**AUDITORIUM RENOVATIONS AT FARRAGUT MIDDLE SCHOOL  
27 FARRUGUT AVENUE  
HASTINGS-ON-HUDSON, NY 10706**

**CONTRACT G – GENERAL CONSTRUCTION, ABATEMENT WORK, AND PLUMBING WORK  
CONTRACT M – HEATING, VENTILATION, AIR CONDITIONING WORK  
CONTRACT E – ELECTRICAL WORK**

**RESPONSES TO WRITTEN QUESTIONS:**

DRAWING No. **EA 102.00**

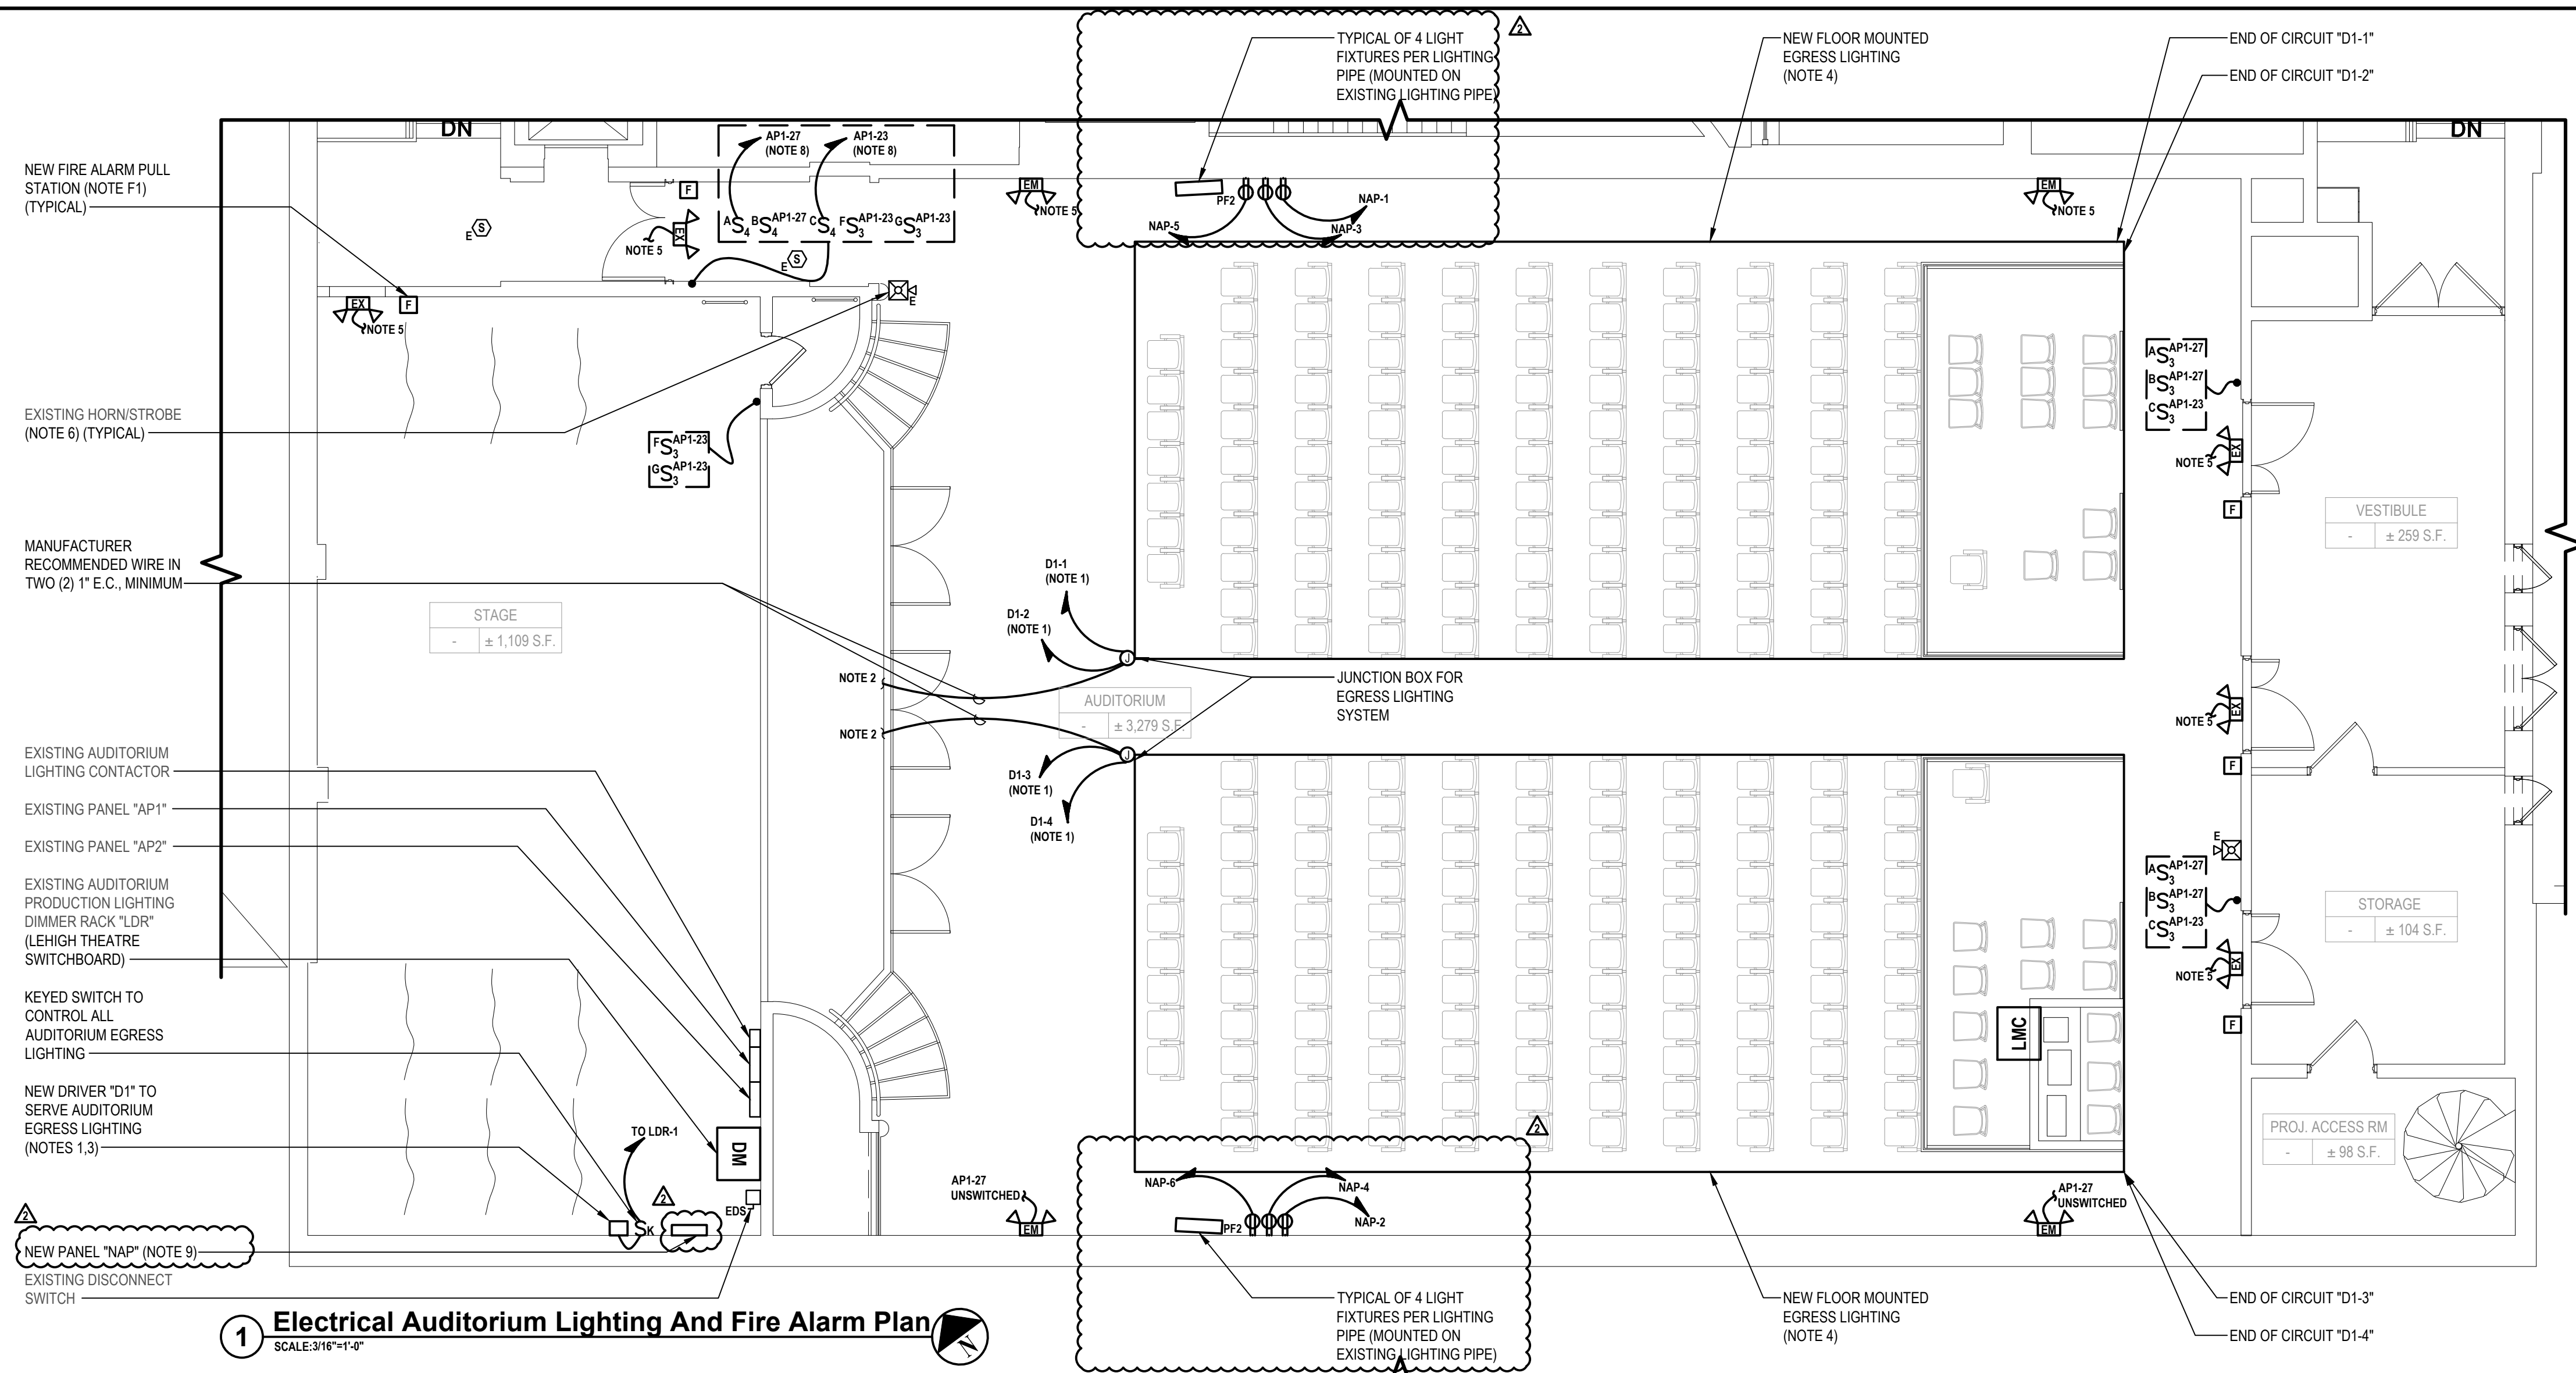
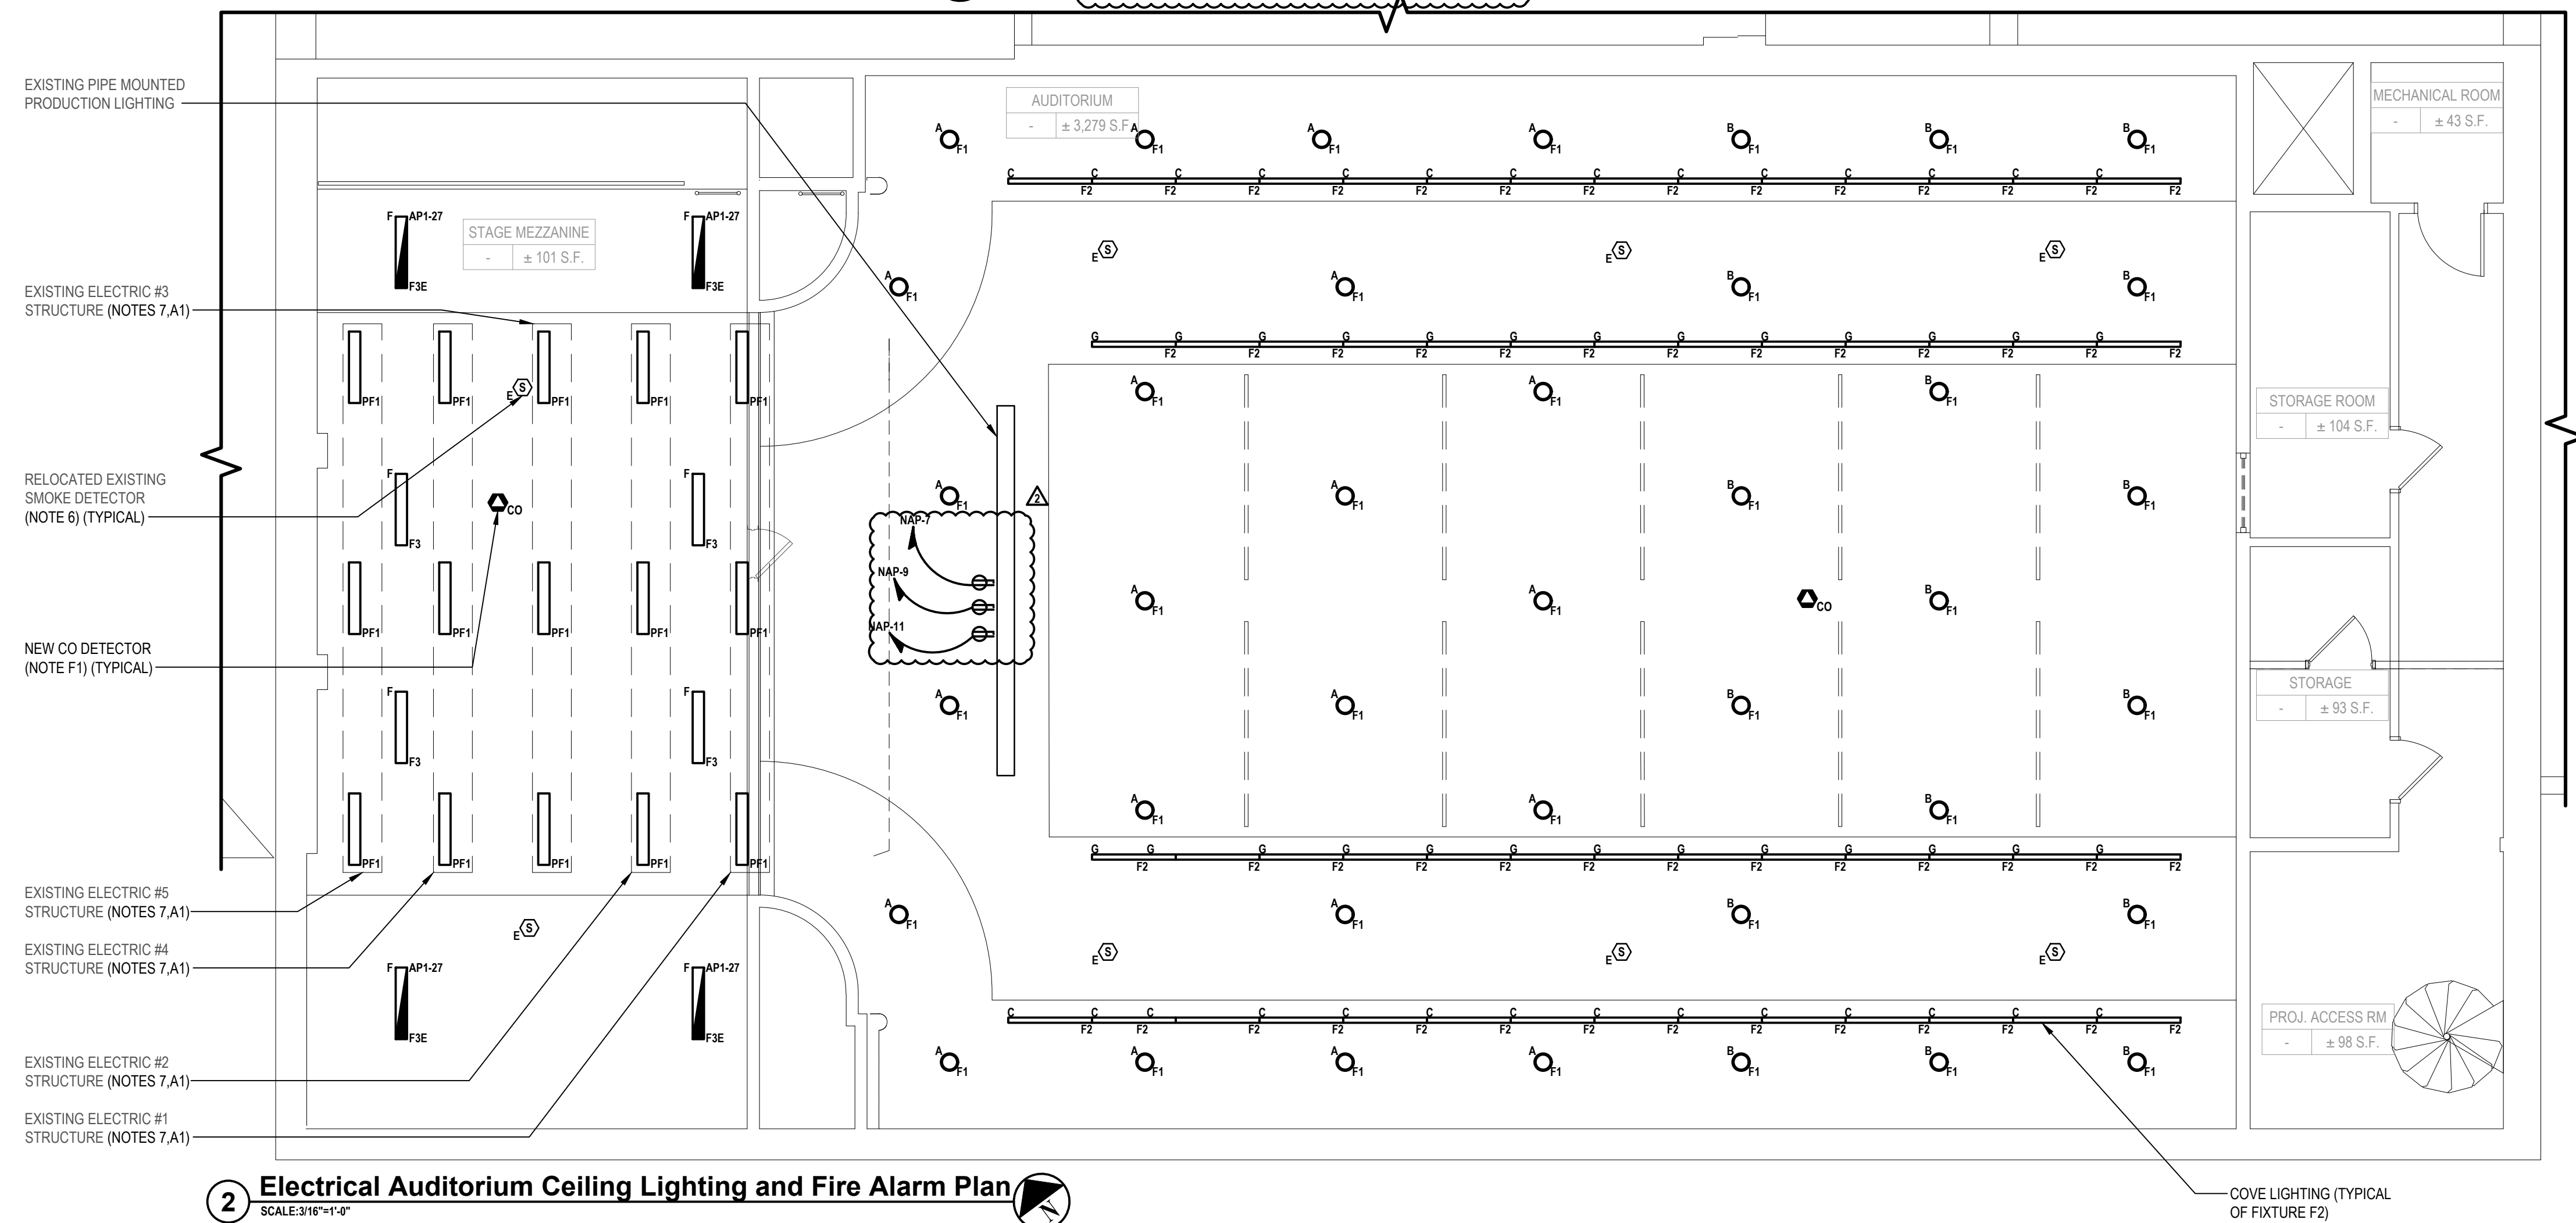
Drawing Plate EA 102.00 indicates EXISTING AUDITORIUM PRODUCTION LIGHTING DIMMER RACK “LDR” (LEHIGH THEATRE SWITCHBOARD). Provide full model numbers.

Reference EA 201/102. What are the quantities of DMX and 20A receptacles on each of the existing to remain and reuse without modification Electrics 1-5? Are the 20A receptacles Edison?

Please see photos attached (IMG\_0419.JPG, IMG\_0421.JPG & IMG\_0423.JPG)

Refer to revised EA 102 drawing.
